Staff Report
City of Richmond, Virginia

Commission of Architectural Review

COA-100316-2021	Final Review	Meeting Date: 10/26/2021
Applicant/Petitioner	Martin Johnson	
Project Description	Remove deteriorated wooden siding and install fiber cement siding.	
Project Location		
Address: 219 N. 28th St.		
Historic District: St. John's Church		
High-Level Details: <ul style="list-style-type: none"> The applicant proposes to replace rotted wood siding on the north elevation of a ca. 1851 Italianate home with unbeaded, smooth hardie plank. The new hardie plank will match the color and profile of the siding on the rest of the house. 		
Staff Recommendation	Denial	
Staff Contact	Emily Routman, Emily.routman@richmondgov.com	
Previous Reviews	The applicant received an Administrative Approval for the replacement of rotted wood siding with smooth hardie plank on the south elevation of the house in September 2021.	
Staff Recommendations	<ul style="list-style-type: none"> Denial of the hardie plank siding. The applicant should replace the rotted wood siding with in-kind materials and color.

Figure 2. Façade photo

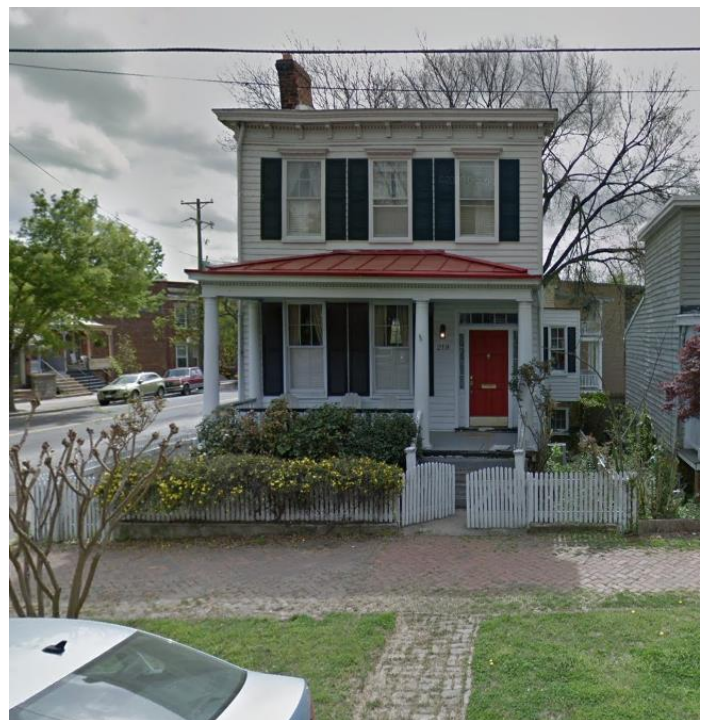
<p>Substitute Materials – Fiber Cement Siding, pg. 60</p>	<p><i>Fiber cement siding is a siding option that has limited application for use on historic properties. Advertised as an alternative to vinyl or wood products, the application of these products in City Old and Historic Districts should be restricted to new freestanding buildings, secondary elevations with limited visibility from the public right-of-way, new additions with limited visibility from the public right-of-way, and new outbuildings. The use of fiber cement siding products as a substitute for original wood trim and siding on historic structures is discouraged. Fiber cement siding is often thinner than wood siding, providing a narrower profile that makes the wall appear flat. Fiber cement siding should reveal a smooth surface, rather than a faux “wood grain.”</i></p>	<p>The applicant proposes to replace historic wood siding with fiber cement, hardie plank siding on a secondary elevation. However, even though it is a secondary elevation, it faces E. Broad Street, the busiest artery in the St. John’s Church District and is visible.</p>
